AGENDA

MILWAUKIE DESIGN AND LANDMARKS COMMITTEE Monday, May 19, 2014, 6:30 PM

Recommend that the Planning Commission approve applications DR-14-03 and WG-14-01 (as part of master file P-14-01) and the recommended Findings and Conditions of Approval found in Attachments 1 and 2. This action would allow for expansion of an existing parking area within the Willamette Greenway zone, including installation of parking lot lighting that matches existing lighting but is not consistent with the style noted in the Downtown Design Guidelines.

REQUEST: Type III Downtown Design Review, Parking Determination, and Willamette River Greenway Conditional Use review approval are requested for the plans for Moda Health to modify and expand the existing western parking lot at their office building by 30 parking spaces.

WESTERN PARKING LOT SITE PLAN

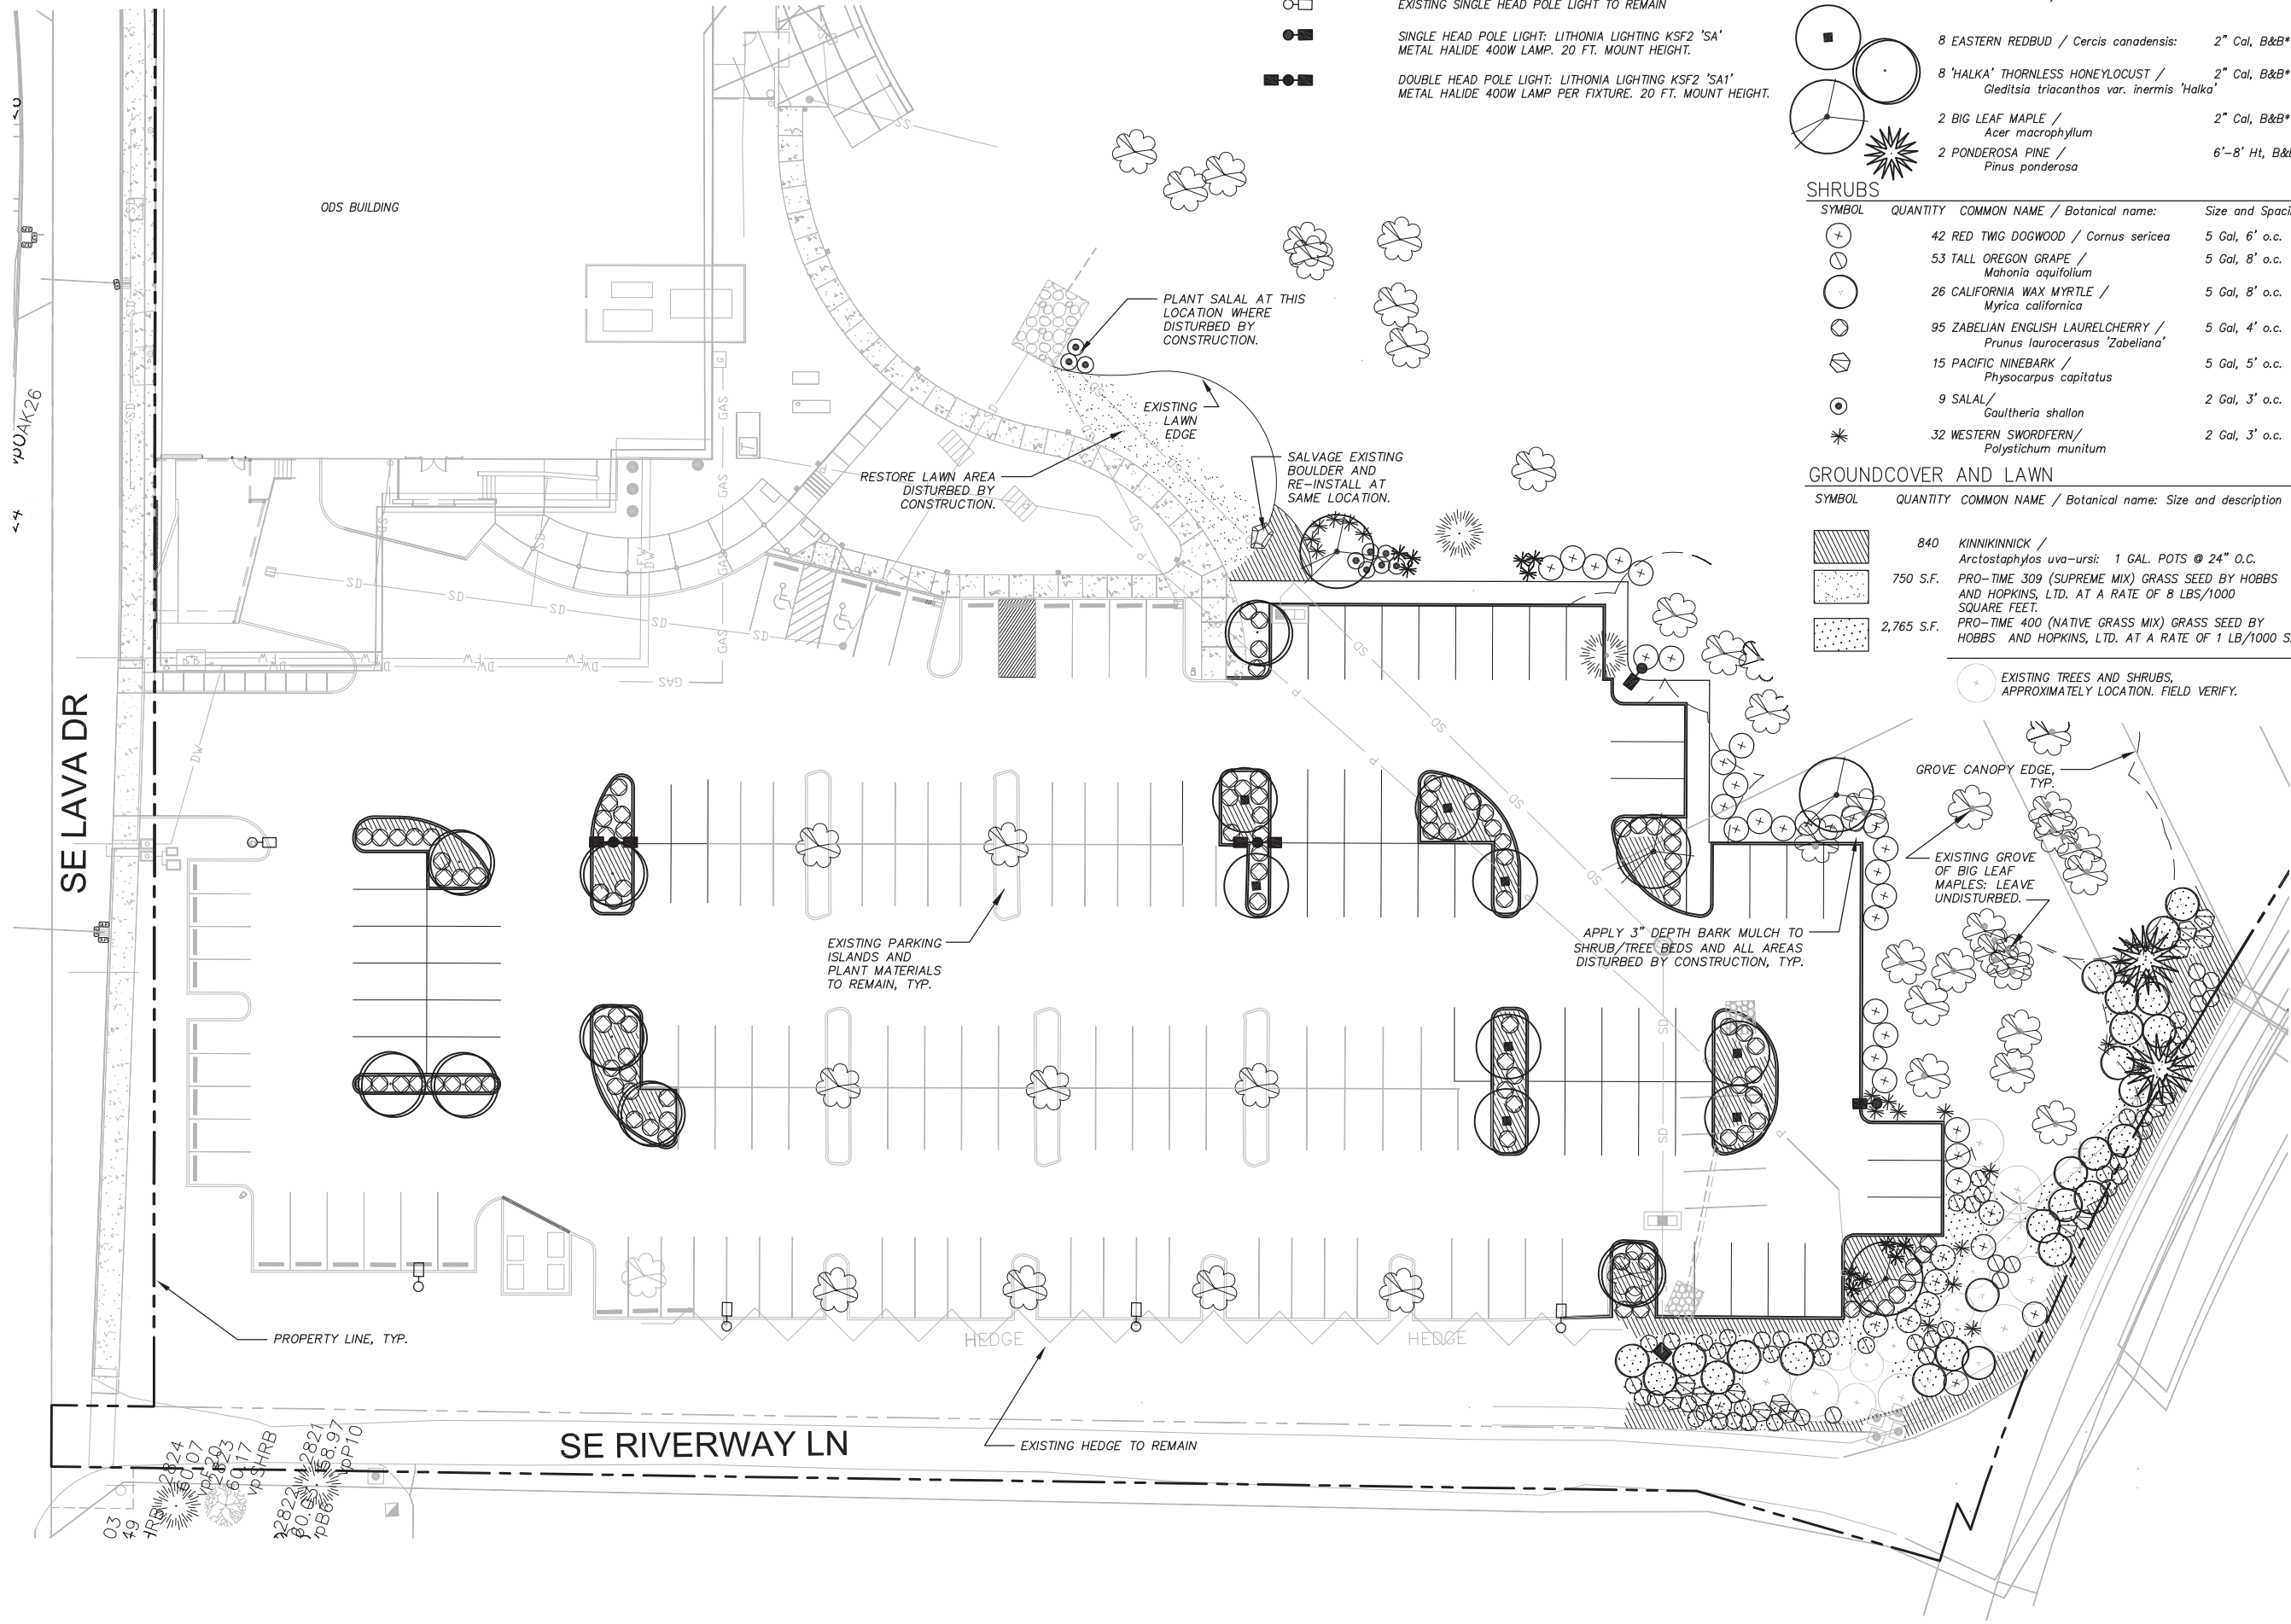
ADA: Parking stalls shall be dimensioned on submittal for permits. ADA ramp at top of side aisle encroaches into walking path. Provide a clear and flat aisle with a minimum of 3 feet clear path. ADA signage shall comply with ANSI A117.1 and Chapter 11 of the Oregon Structural Specialty Code.
